**Department of Economic and
Development Services
Planning Division**

**PLANNING COMMISSION STAFF REPORT
PUBLIC HEARING**

Application Types	Type III Design Review
Application Numbers	DR 2014-02, VAR 2014-01
Project Description	The applicant requests a Design Review for five commercial buildings totaling 52,000 square feet of gross floor area, and a Variance to the requirement for a screening wall abutting residential development along Robin Avenue.
Project Location	3001 Newberg Highway, tax lot 052W12BC06600
Zoning	Commercial General (CG)
Property Owner	Master Development, LLC
Applicant	Schirmer Satre Group
Planner Assigned	Don Dolenc, Associate Planner
Application Received	August 12, 2014
Application Complete	October 13, 2014
120-Day Deadline	February 10, 2015
Date of Staff Report	October 16, 2014
Date of Public Hearing	October 23, 2014

Location of Required Screening Wall

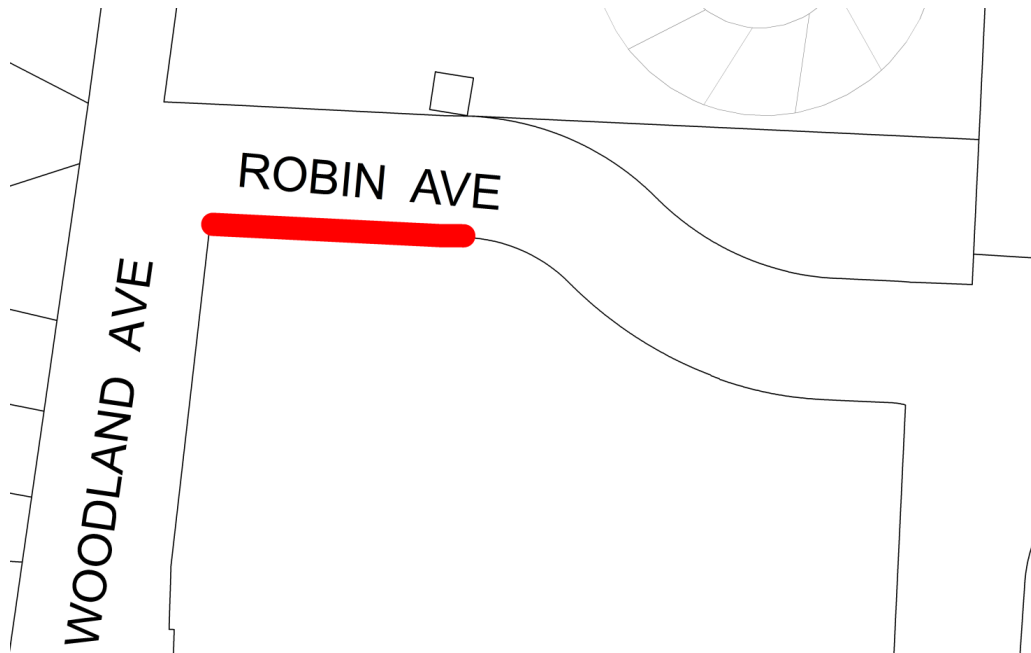
Section 5.03.12.B provides that a variance from development standards may be granted when strict adherence to the WDO standards is not possible, or imposes an excessive burden on the property owner, and when variance to the standards will not unreasonably impact adjacent existing or potential uses or development. The applicant has requested a variance to eliminate the required screening wall along the portion of Robin Avenue abutting residentially-zoned property and a manufactured dwelling park.

Applicant's statement: "Strict adherence to the standards of this ordinance is not possible for the majority of the length of the area where the architectural wall is required. Site distance standards for safe egress from the property, (as per the Transportation Assessment letter by Kittelson & Associates, Inc. Page 7, submitted with the Design Review III application) recommend that for a certain area there can be no site obstructions taller than 30 inches. See Site Plan Sheet L3.0. A site distance line has been indicated on the drawing. It is measured from a point 14½ feet back to a place in the center of the oncoming lane.

Due to the horizontal curvature of Robin Avenue along the north site frontage, it is important to ensure that there is an adequate departure sight triangle for the northbound left and right turn exiting lanes. The departure sight triangle for each movement is shown in Figure 2. To ensure the maximum amount of intersection sight distance for these two movements, it is recommended that all street trees and above ground utilities be kept clear of the departure sight triangles and that any landscaping be limited to low lying ground cover.

Conclusions: The property is not “unbuildable by application of the WDO.” The requested variance would not alter existing patterns of traffic, drainage or other physical or natural systems, or be materially injurious to adjacent properties. The requested variance does not conflict with the Woodburn Comprehensive Plan.
